STATE OF TENNESSEE
DEPARTMENT OF TRANSPORTATION
BUREAU OF ENGINEERING

I-65 INTERCHANGE AT BUCKNER ROAD
IN SPRING HILL (DESIGN-BUILD)

REV. 09/14/20: REVISED INDEX OF SHEETS.

TYPE	YEAR	PROJECT NO.	SHEET NO.
FUNCT.	2020		7B

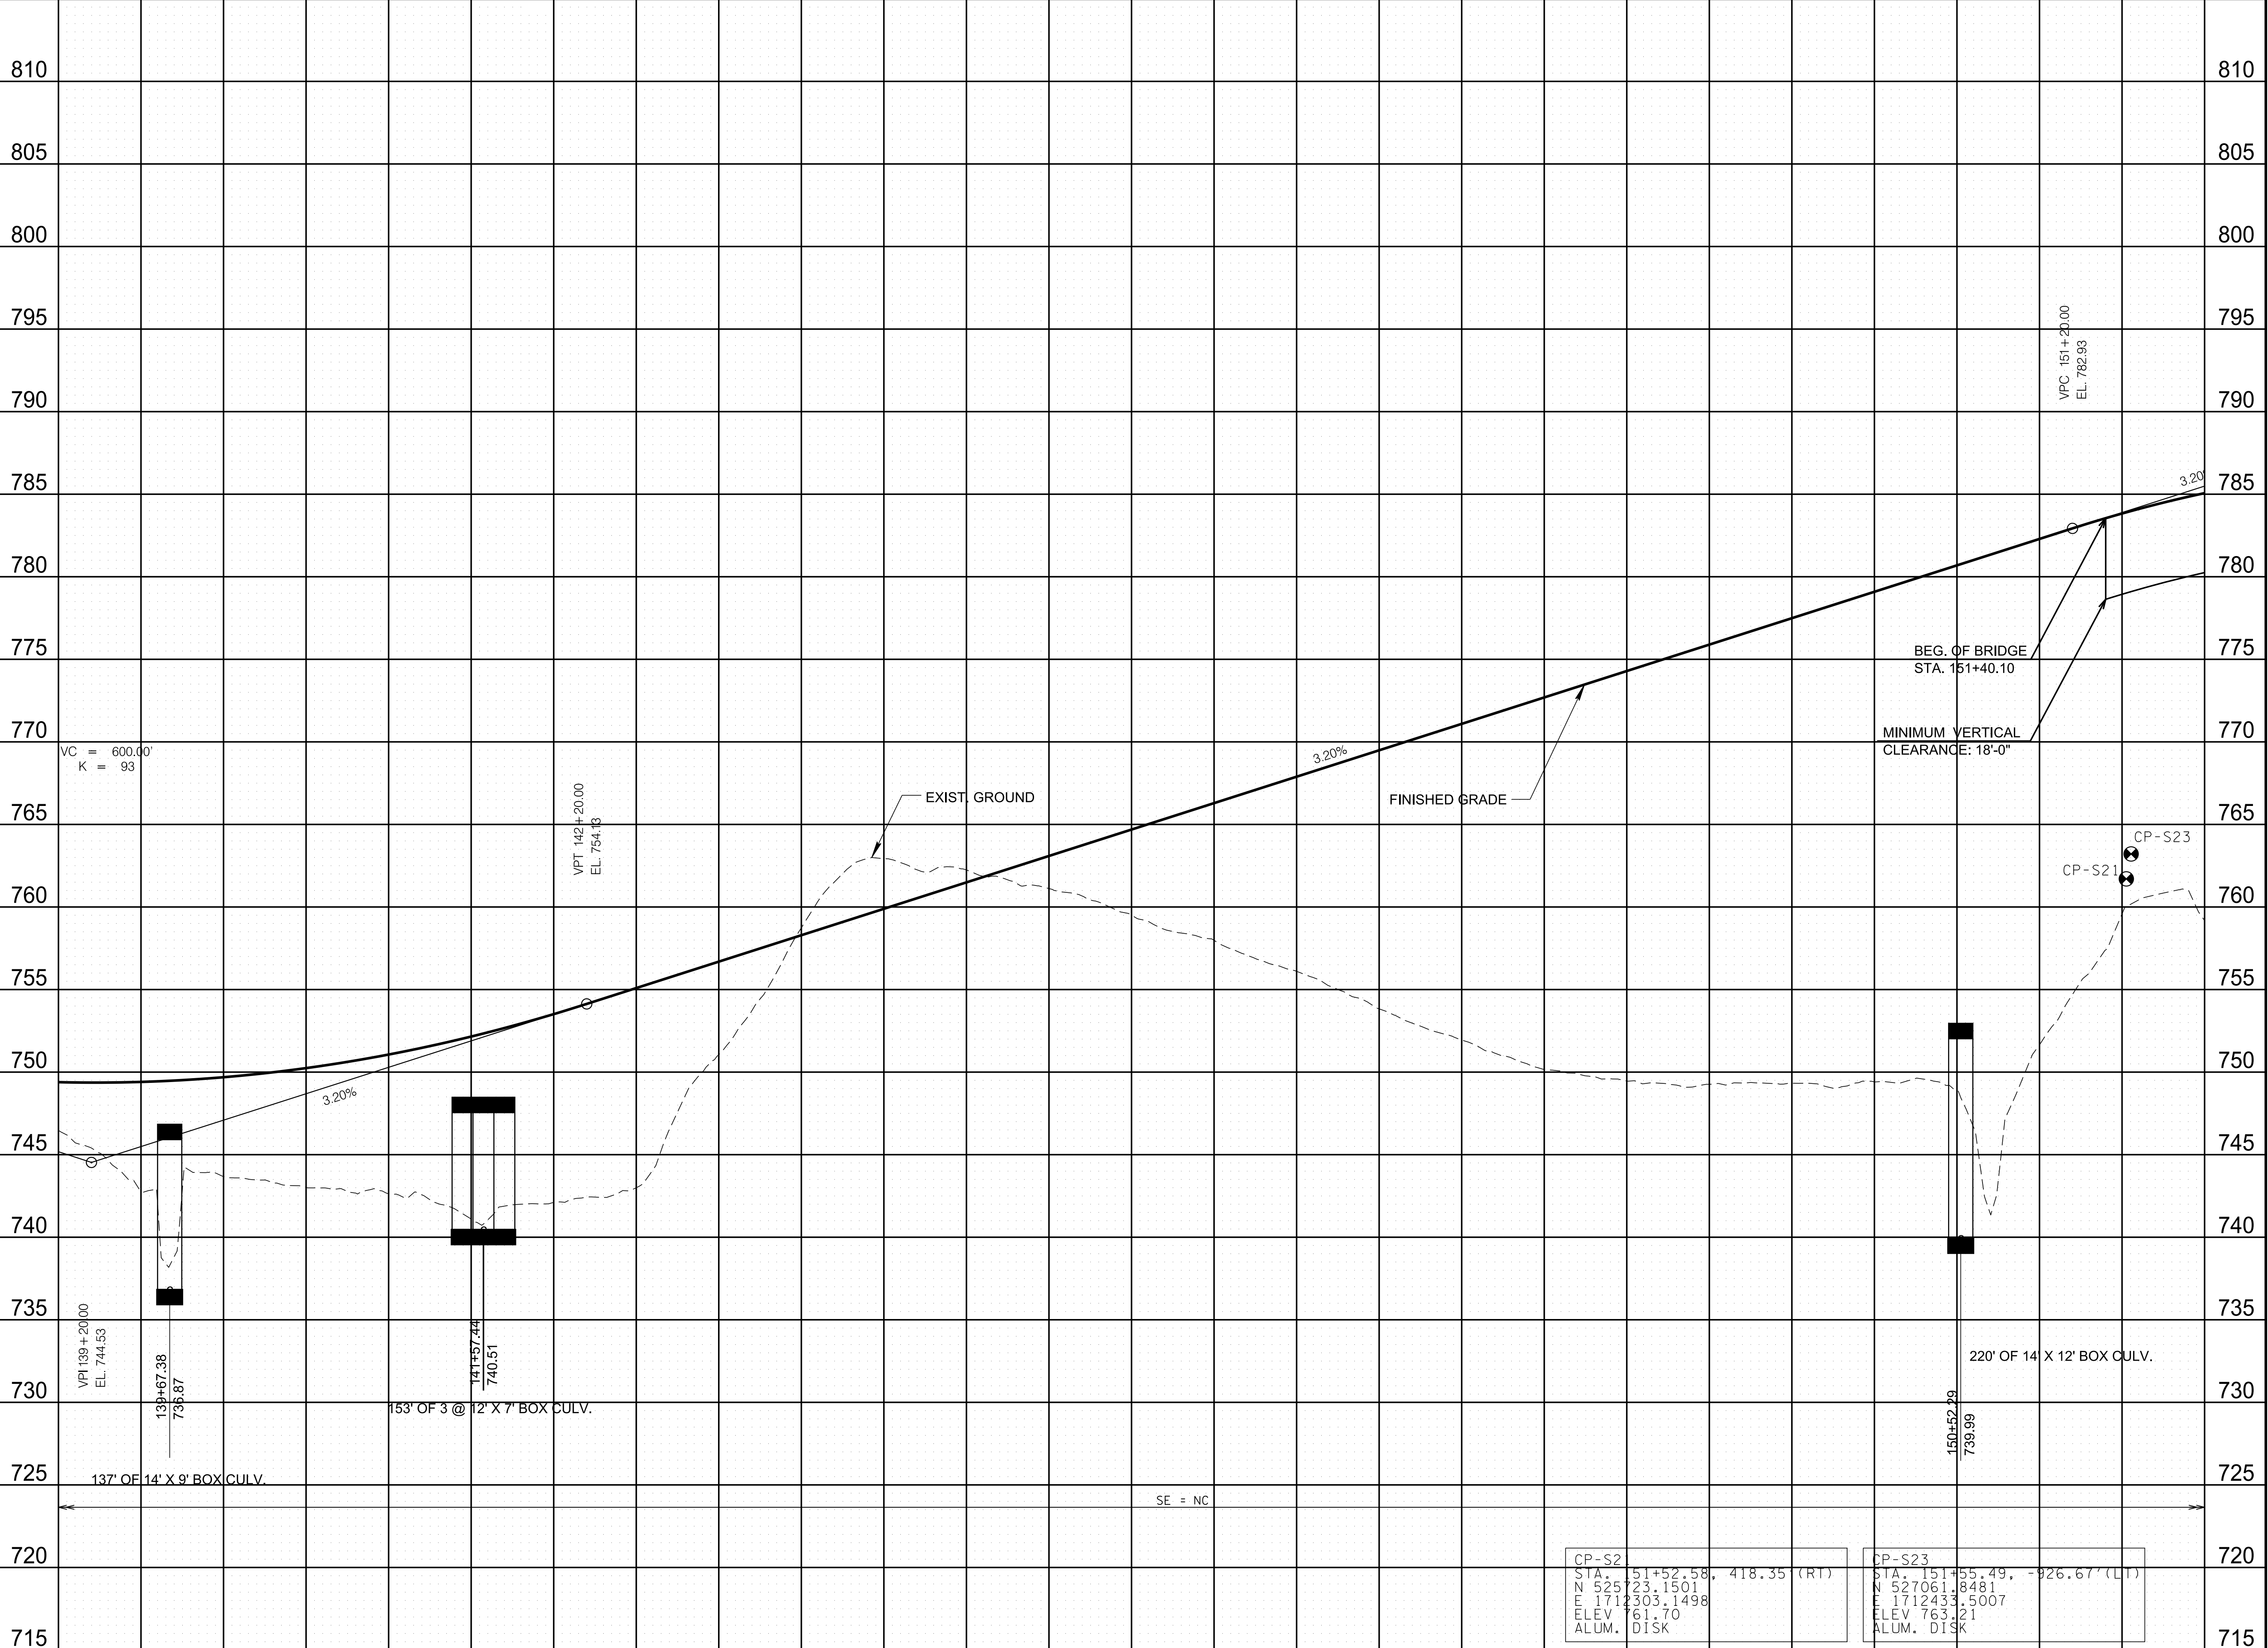
REV. 09/14/20: REVISED 14'X9' RCBC AT STA. 139+67.38 AND 12'X7' RCBC AT STA. 141+57.44.

TYPE	YEAR	PROJECT NO.	SHEET NO.
FUNCT.	2020		8A

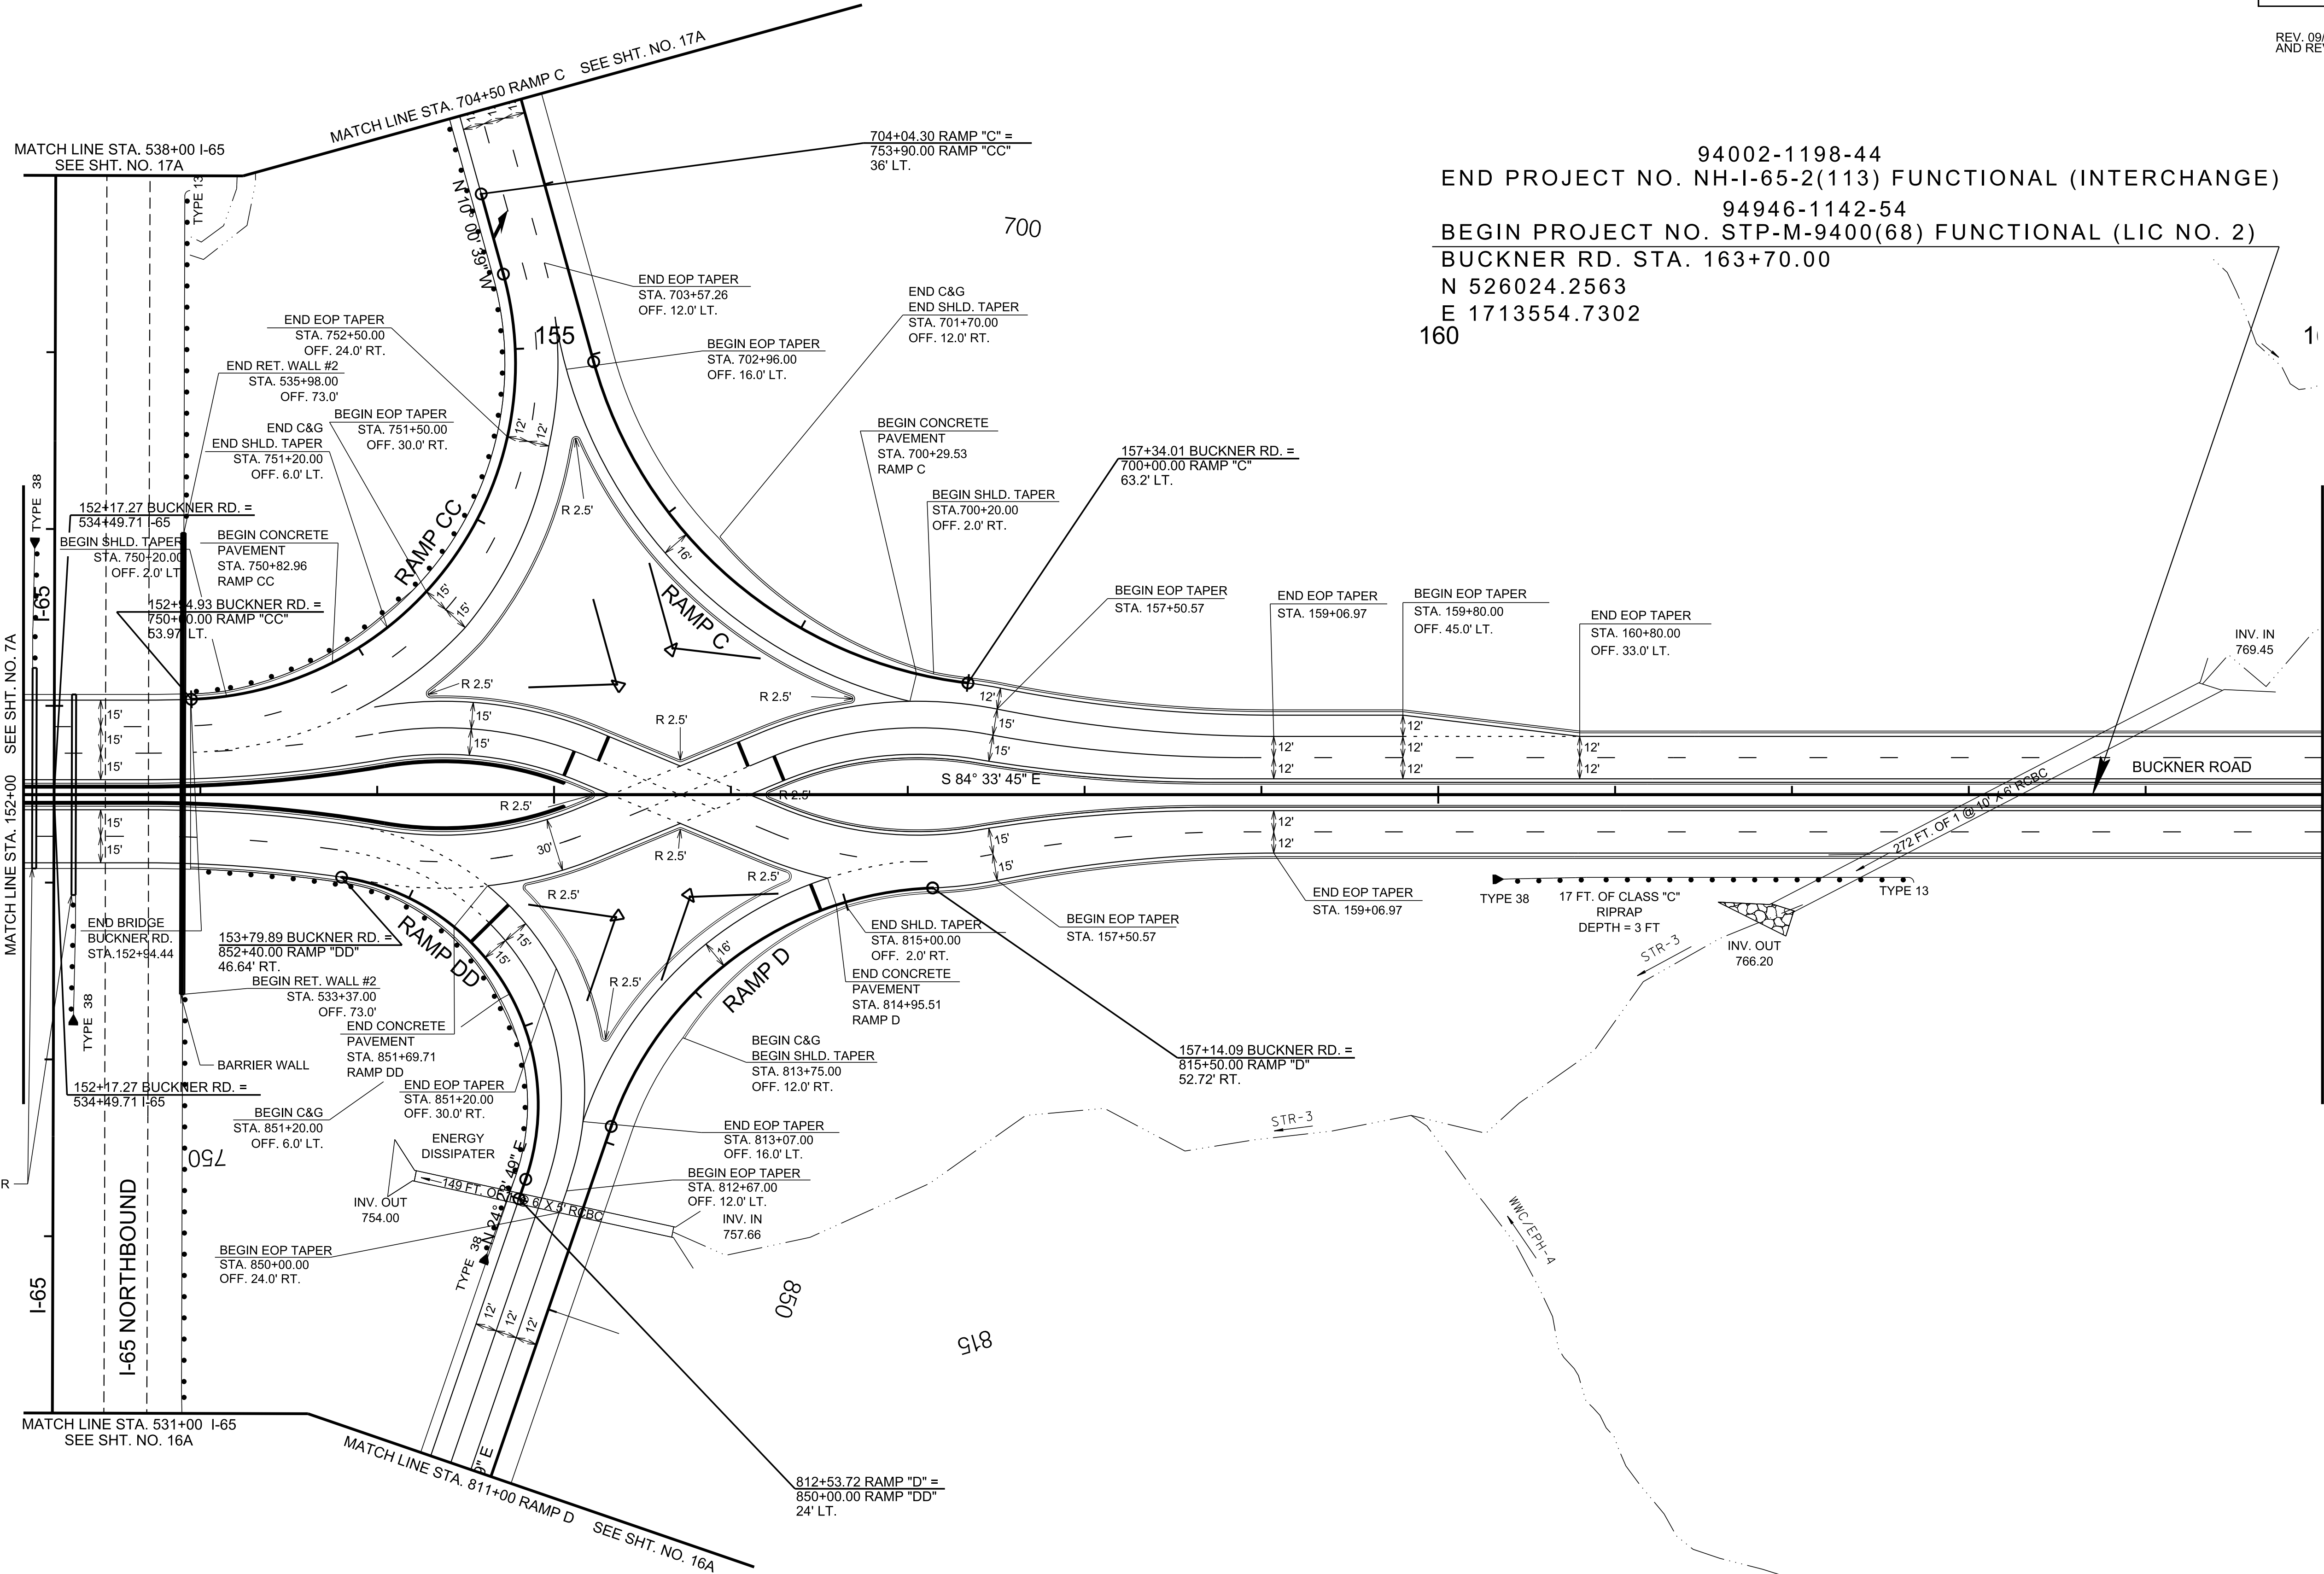
REV. 09/14/20: REVISED 10'X6' RCBC AT STA. 163+18.11 AND REVISED GUARDRAIL ALONG BUCKNER RD.

TYPE	YEAR	PROJECT NO.	SHEET NO.
FUNCT.	2020		9

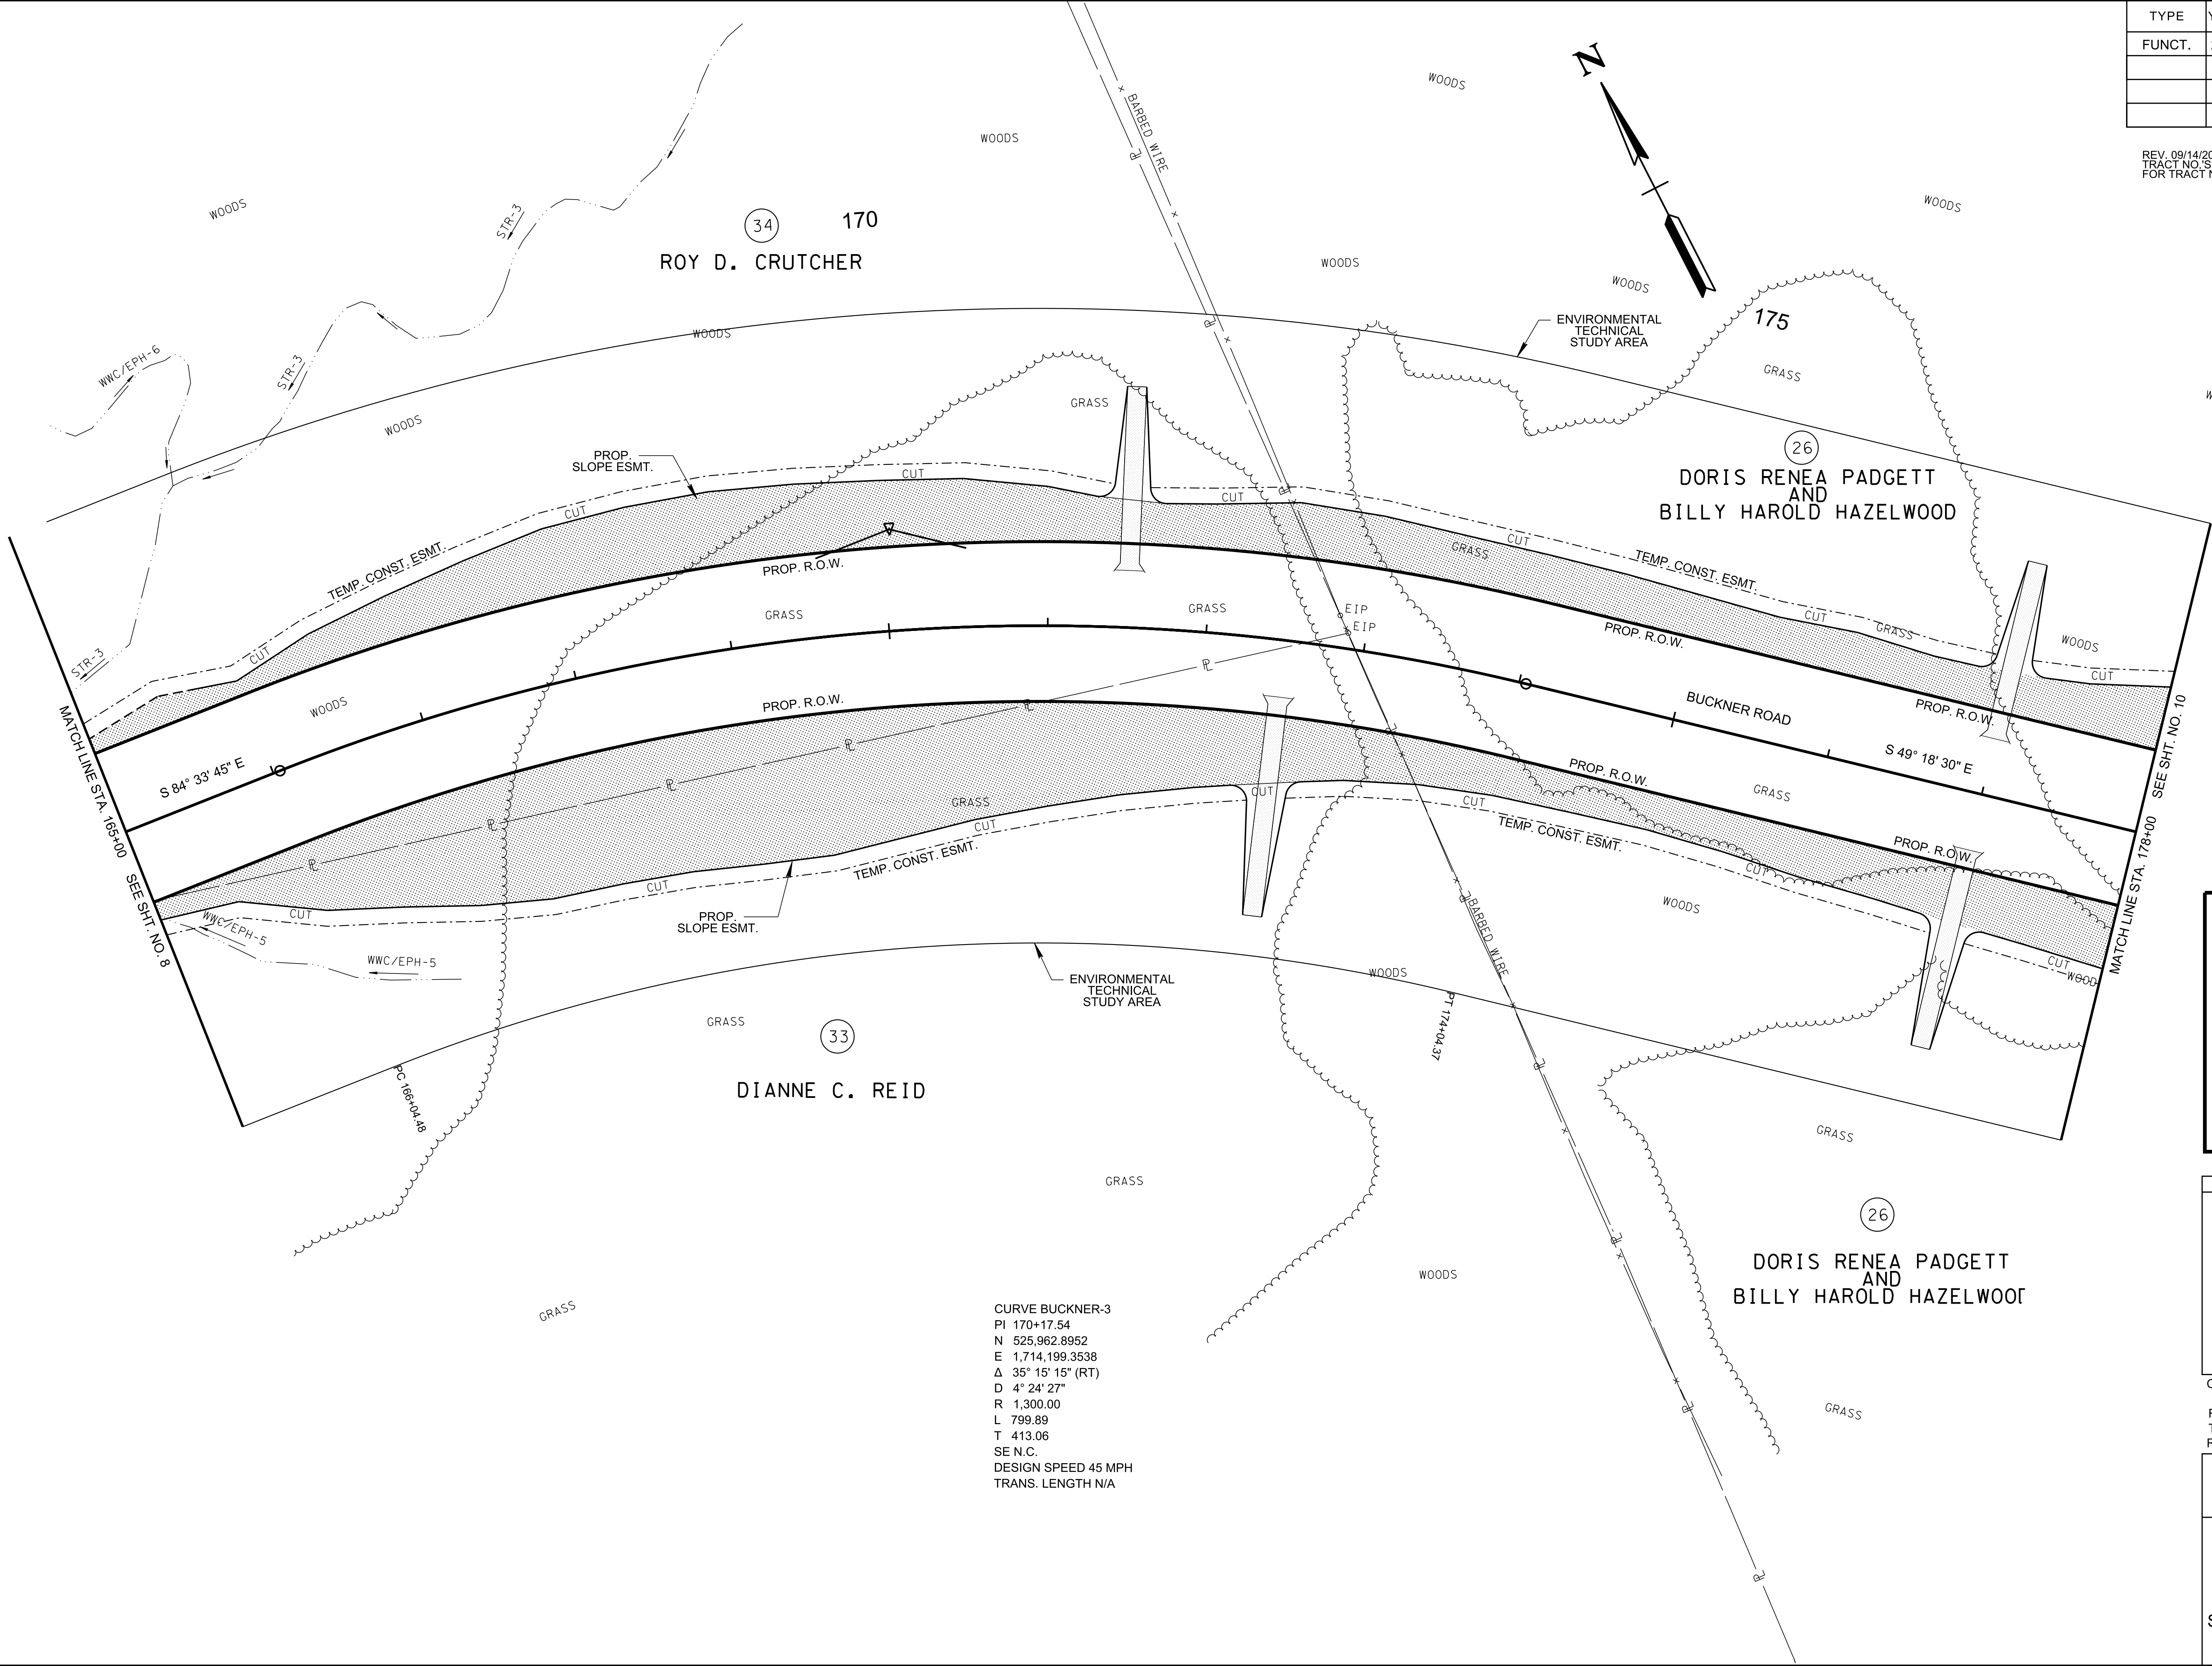
REV. 09/14/20: REVISED TRACT NO. 18 AND ADDED TRACT NO.'S 32, 33, & 34. ADDED FIELD ENTRANCES FOR TRACT NO.'S 26, 33, & 34.
